**Subject: Committee Request for Additional Information  
Polk Street Maintenance  
Chatham County, Georgia**

**RLC# 08-028**

## TECHNICAL MEMORANDUM NO. 21-002

**SUBJECT:** Update to 2014 hydrological and ecological assessment of proposed Polk Street maintenance project, City of Tybee Island, Georgia.

PREPARED FOR:  
**RESOURCE & LAND CONSULTANTS**  
 A TOPOGRAPHIC SURVEY OF  
 A PORTION OF POLK STREET  
 &  
 #318 POLK STREET  
 TYBEE ISLAND  
 PIN: 40025 01005Y

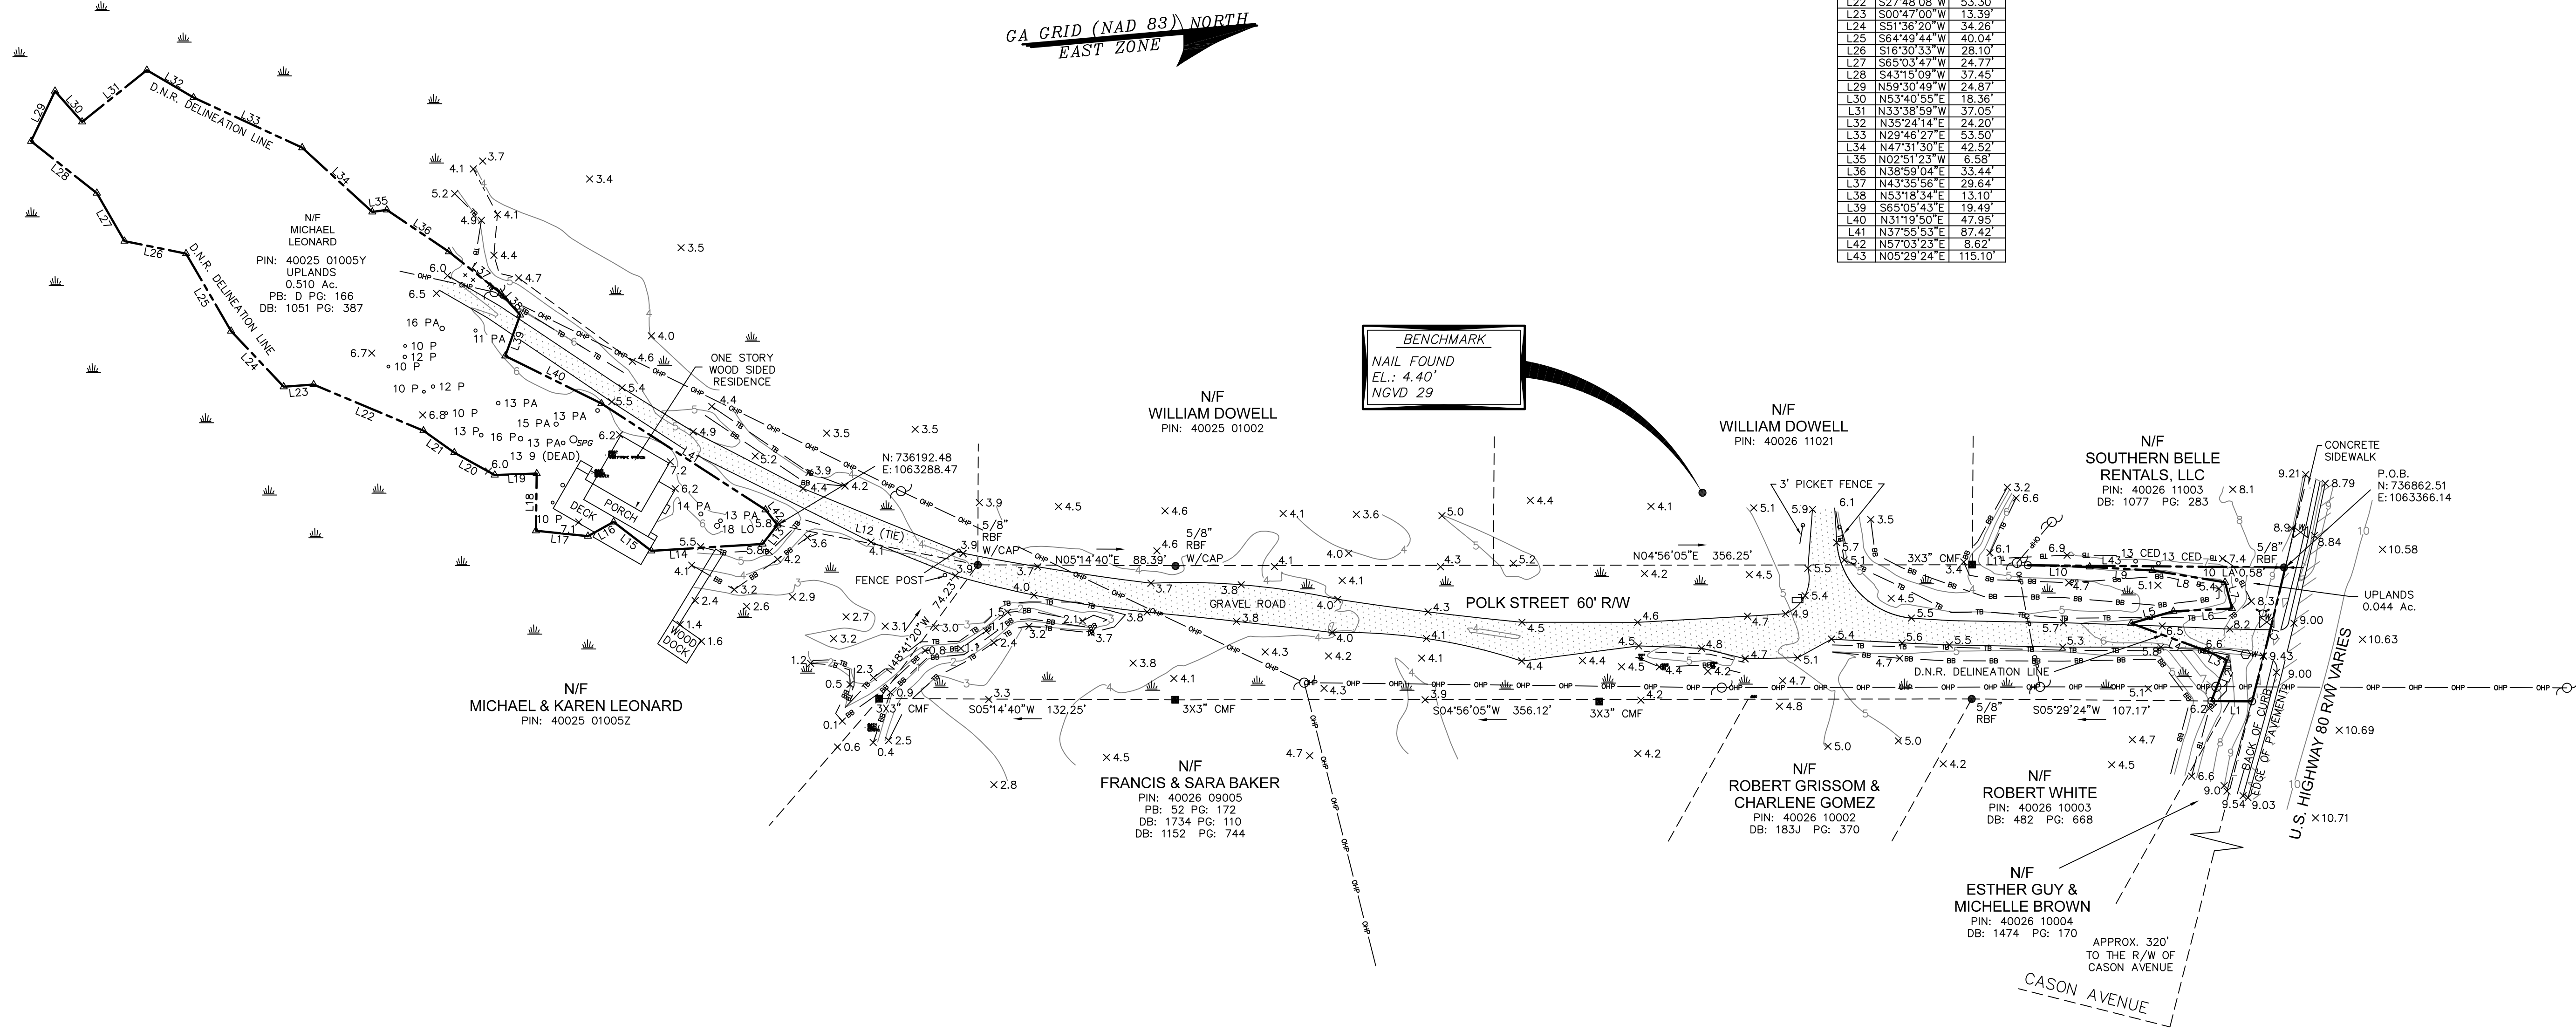
1. *A current topographic survey of the project corridor:* For review, we have attached the 2010 topographic survey completed by Bert Barrett (retired) and the 2021 topographic survey completed by Atlas Surveying. A brief comparison of the two surveys documents minimal change in site conditions since 2012.

sheet:  
**C2**

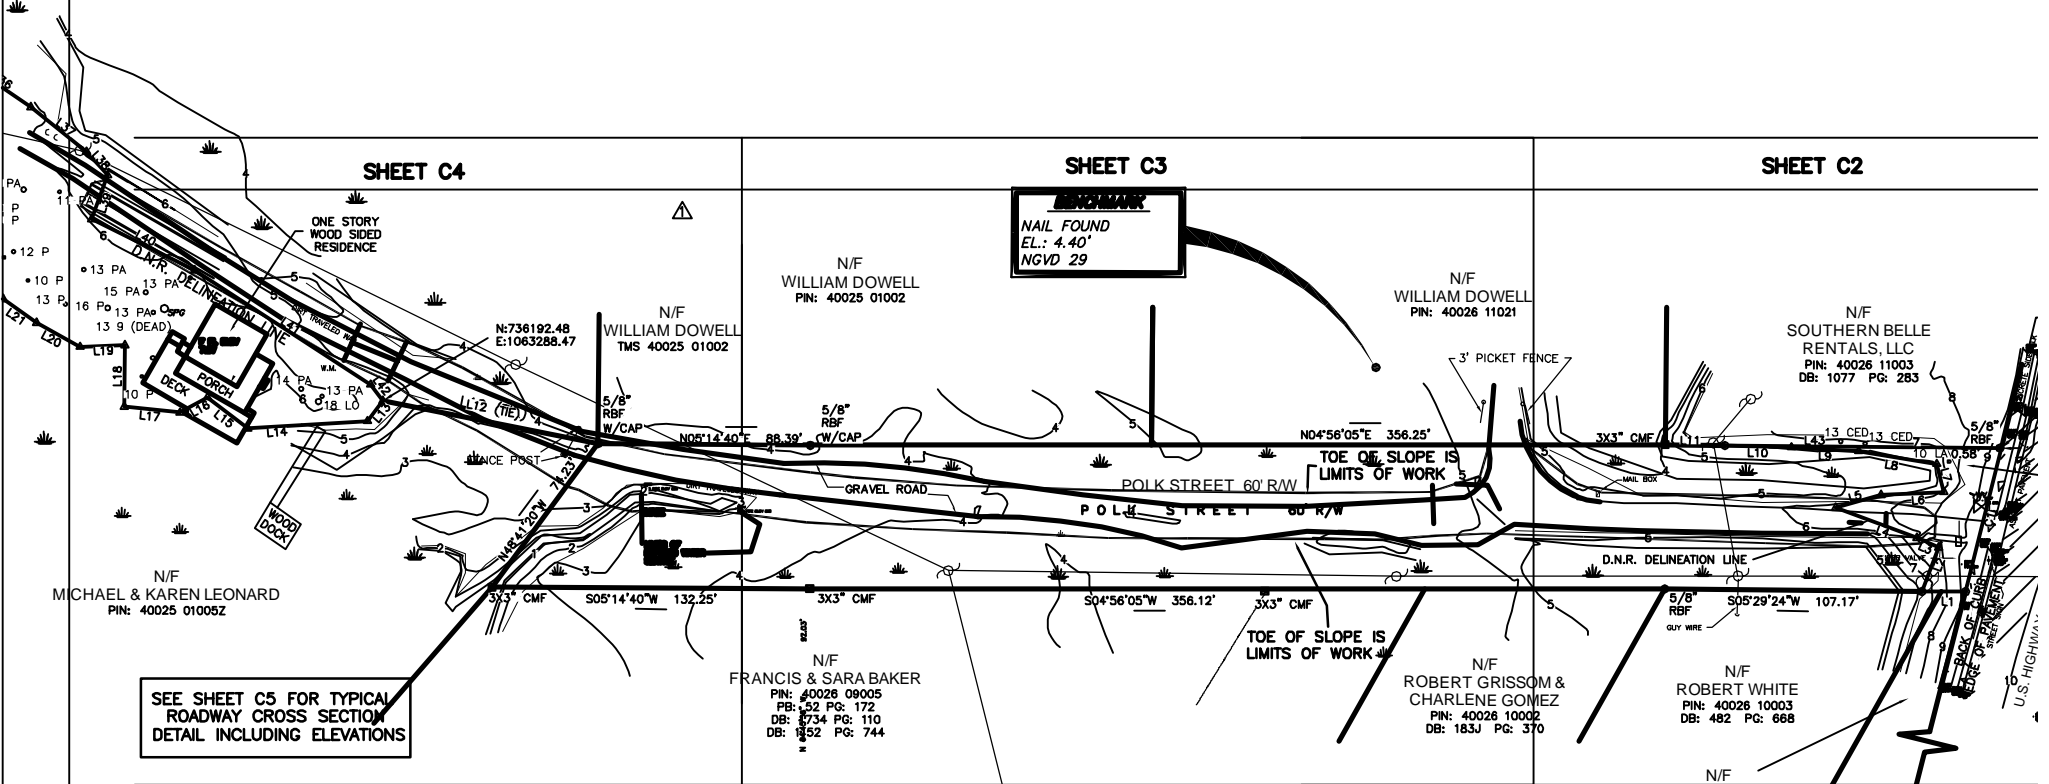
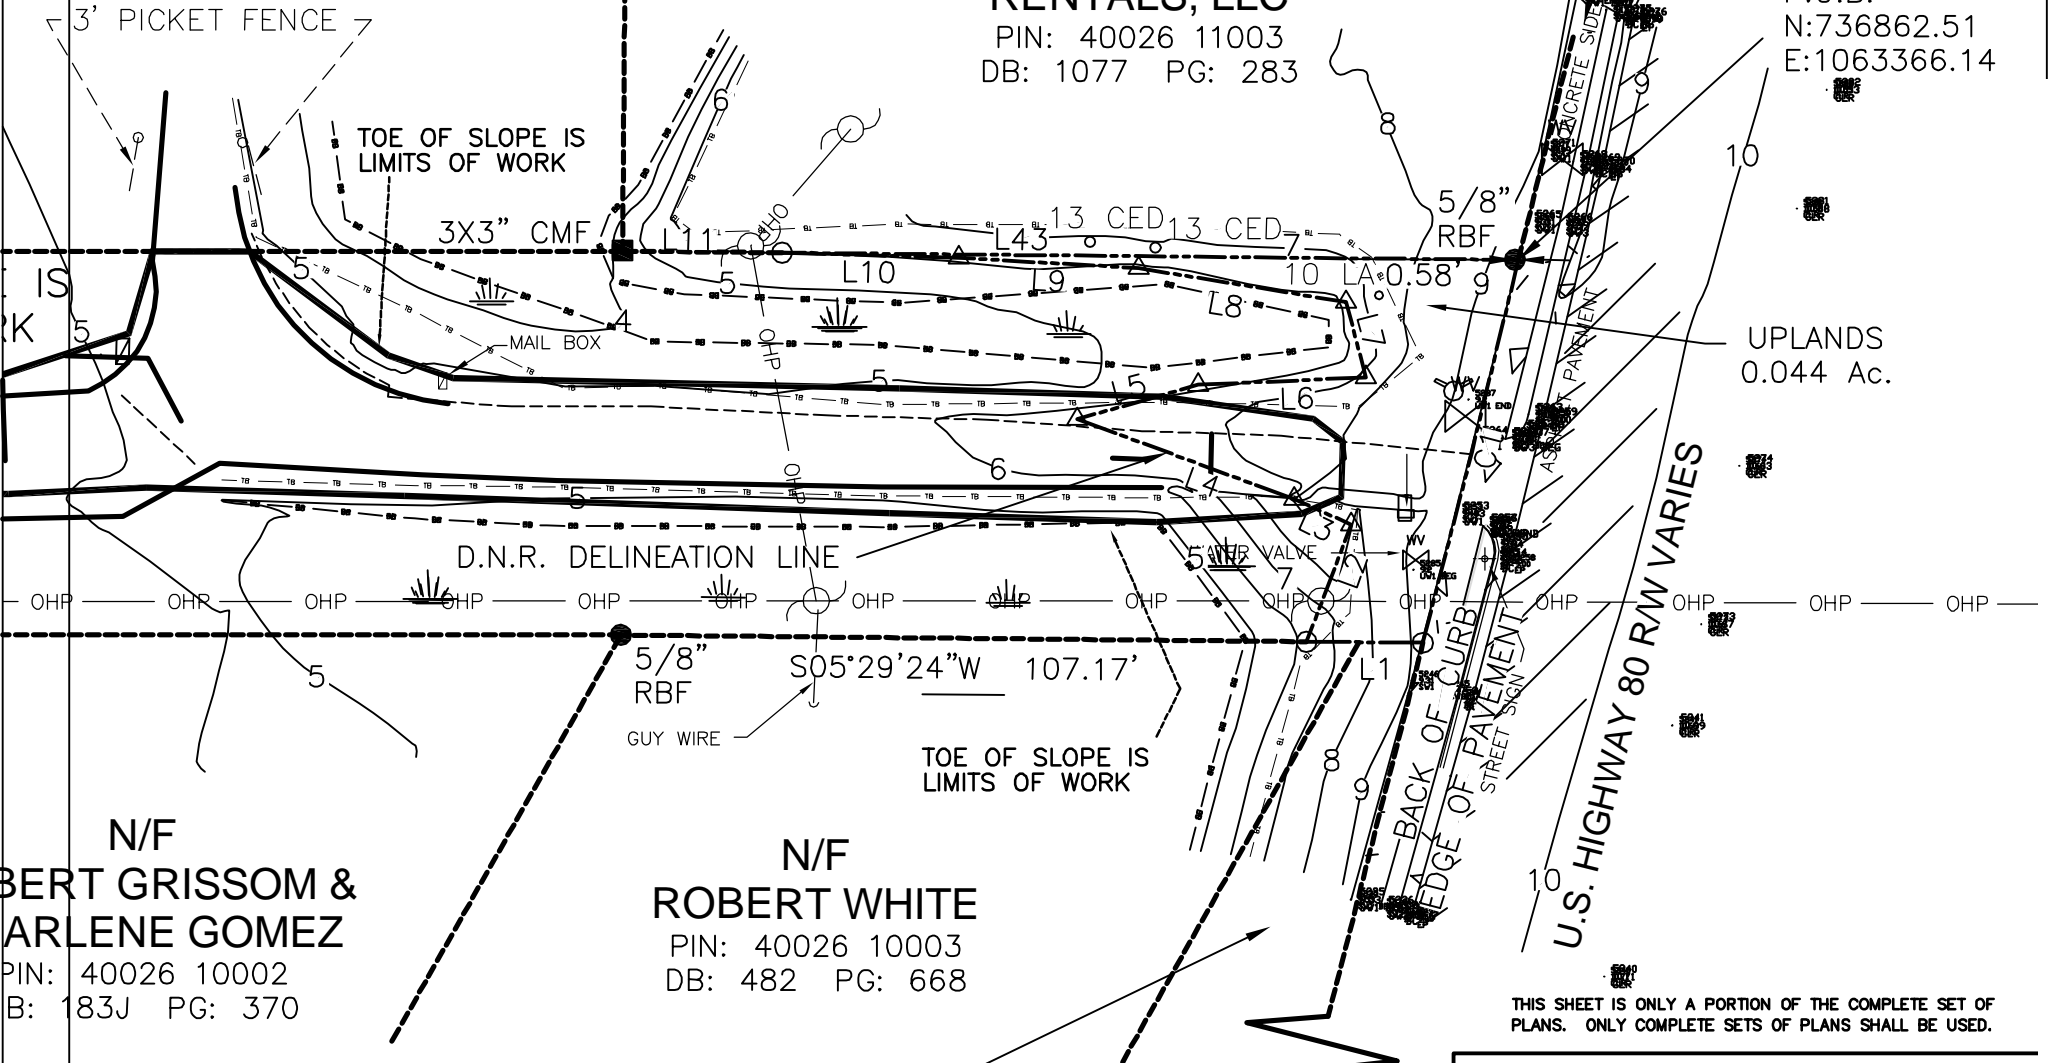
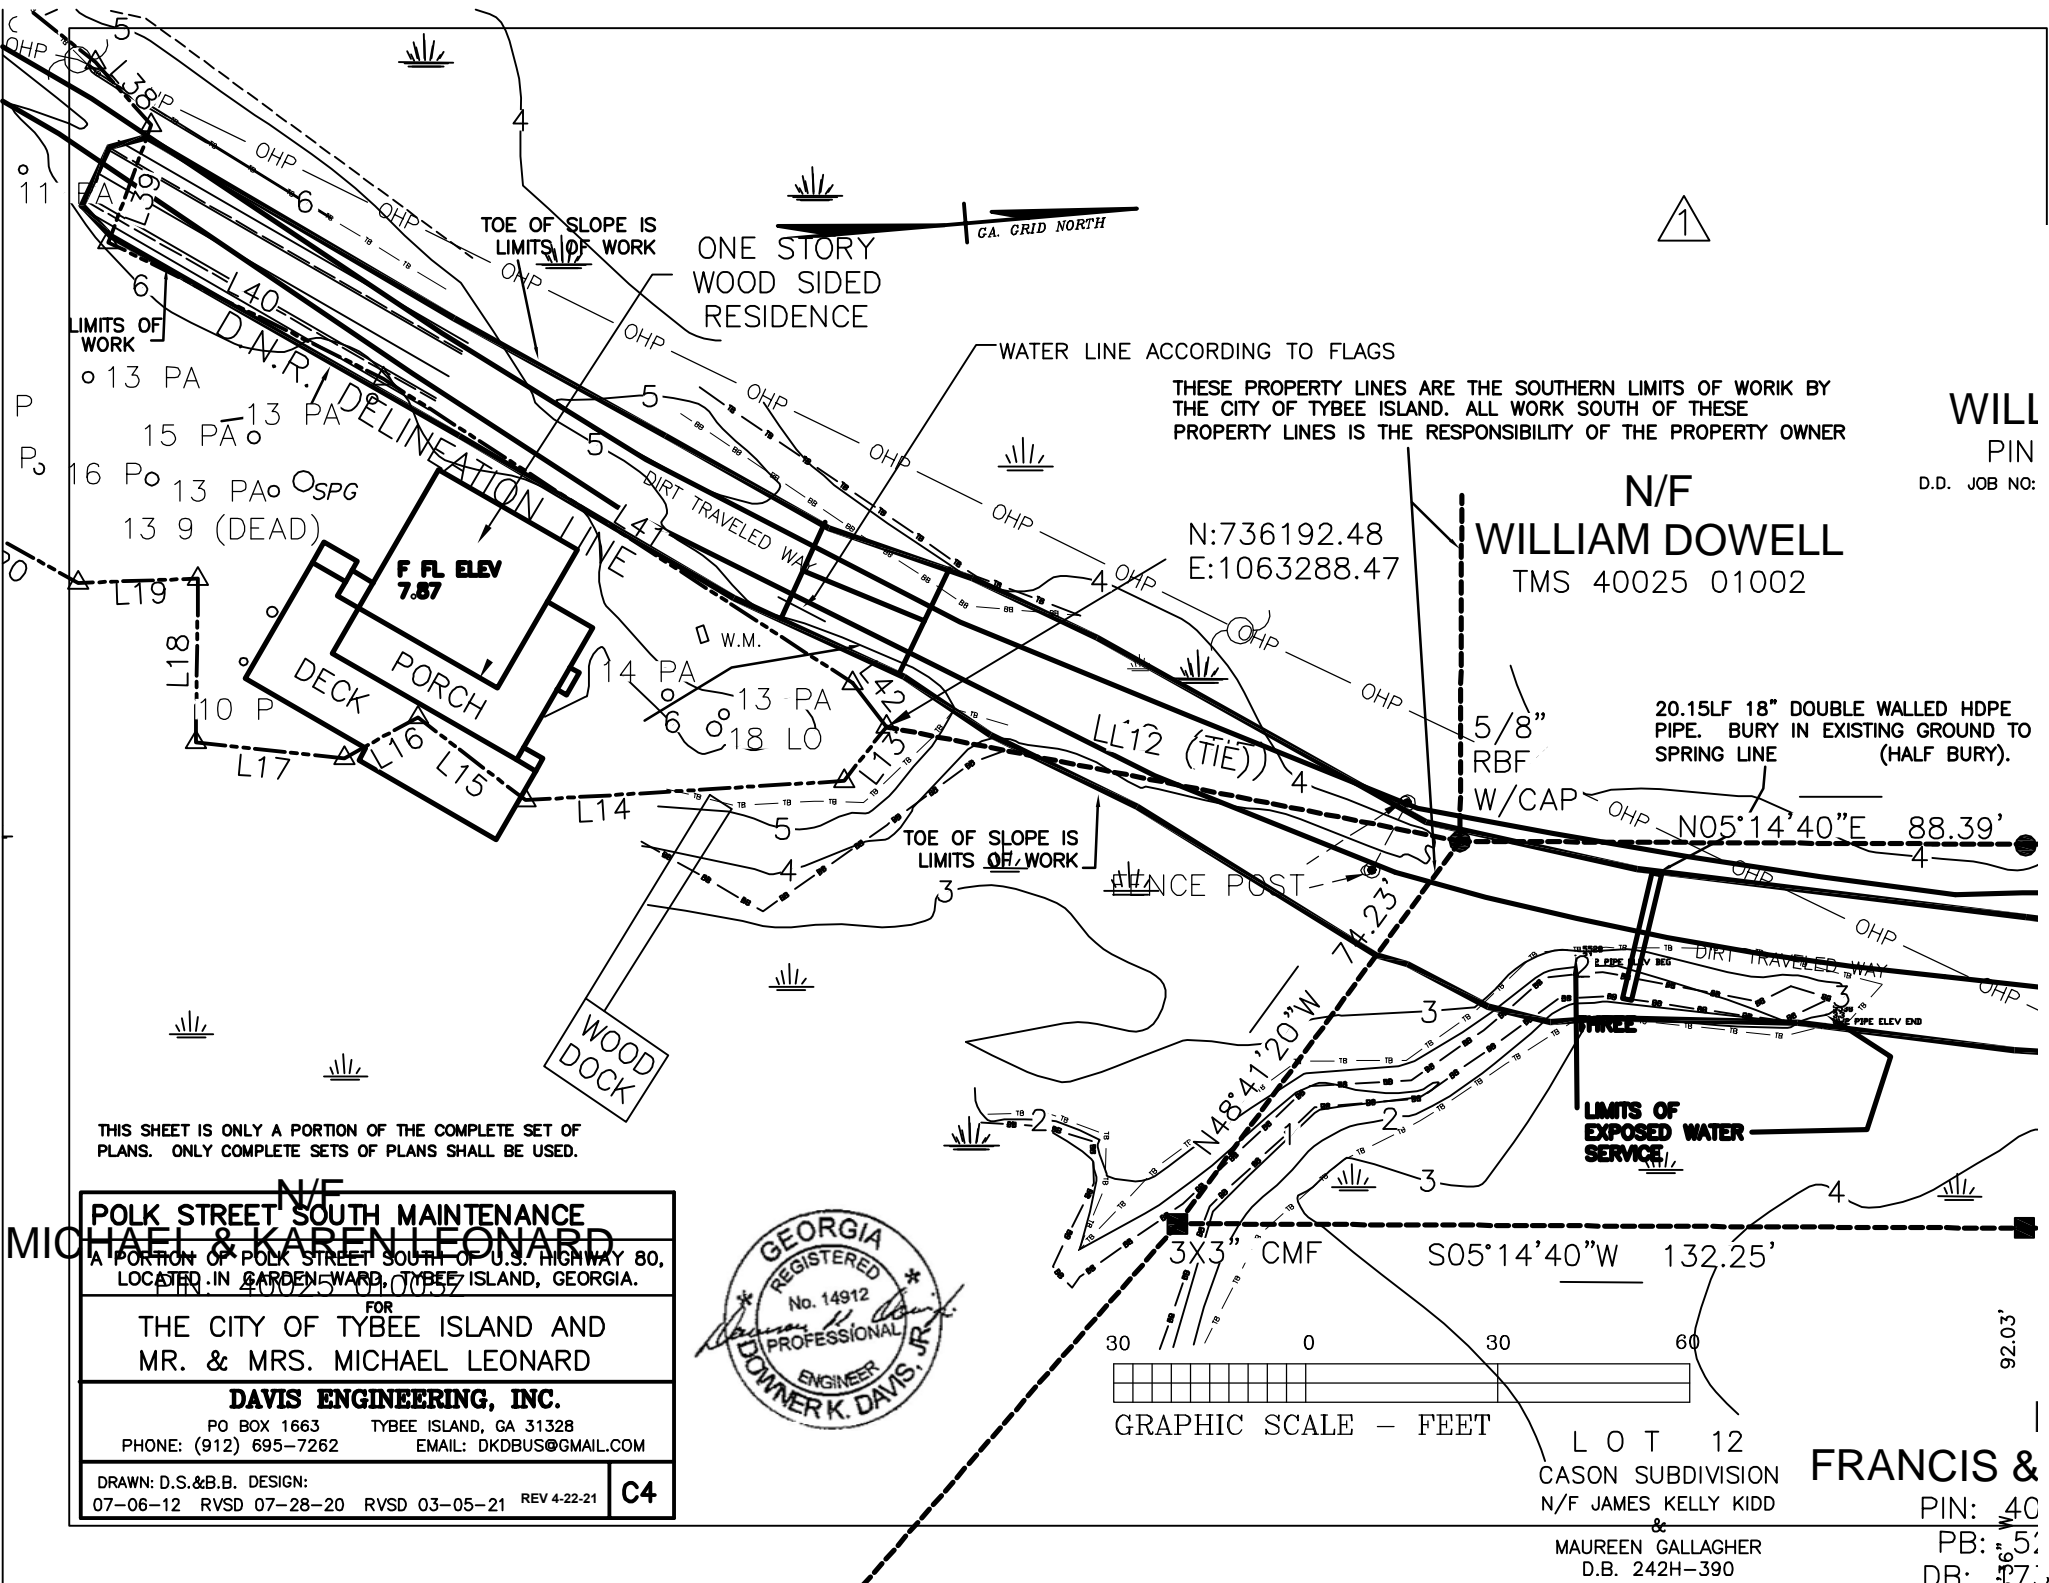
4. *Include 172 feet of western portion of driveway in project impact.* The attached revised permit drawings incorporate the 172 feet of roadway into the overall project.

**POLK ST. MAINTENANCE PERMIT**  
 SHEET NAME:  
**FILL SECTION**  
 CLIENT:  
**RESOURCE + LAND CONSULTANTS**  
 LOCATION: TYBEE ISLAND, GA  
 DATE: 02/19/2021      DRAWN BY: KHT      SHEET: EX1  
 JOB NUMBER: J-29077      REVIEWED BY: JVG      SCALE: 1" = 100'

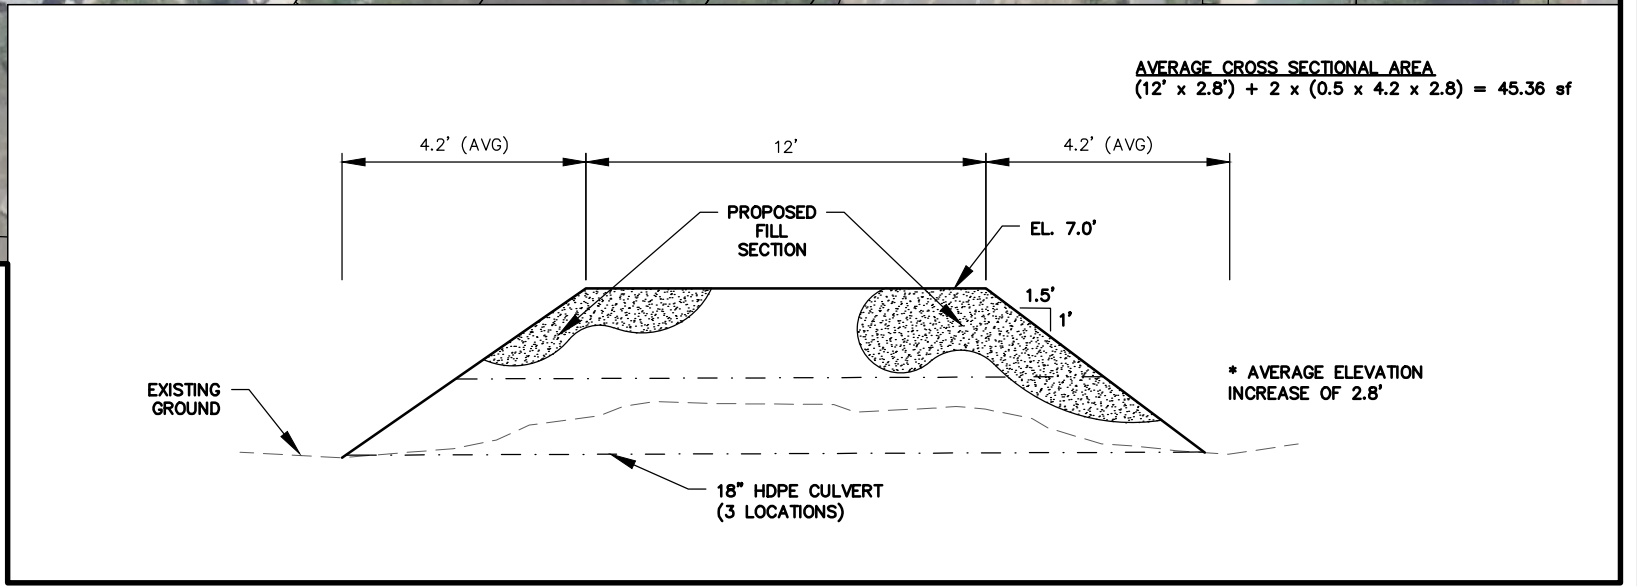
7. *Provide analysis of wooden bridge for all or portions of the project:* Thomas & Hutton was retained to complete a cost assessment for maintenance design alternatives including road fill, concrete bridge and wooden bridge. As documented in the attached exhibits the estimated project costs are as follows:

<b>Maintenance Design</b>	<b>Estimated Unit Cost</b>	<b>Estimated Cost</b>
Road Fill (460 lf)	\$3.40/sf	\$32,769.00
Concrete Bridge (460 lf)	\$250/sf	\$1,725,000.00
Timber Bridge (460 lf)	\$215/sf	\$1,483,500.00
Concrete Bridge (three sections/319 lf)	\$325/sf	\$1,555,125.00
Timber Bridge (three sections/319 lf)	\$275/sf	\$1,315,875.00

**EST. CONSTRUCTION COST TO FILL ROAD = \$13,914 + \$13,455 + \$5400 = \$32,769.00**
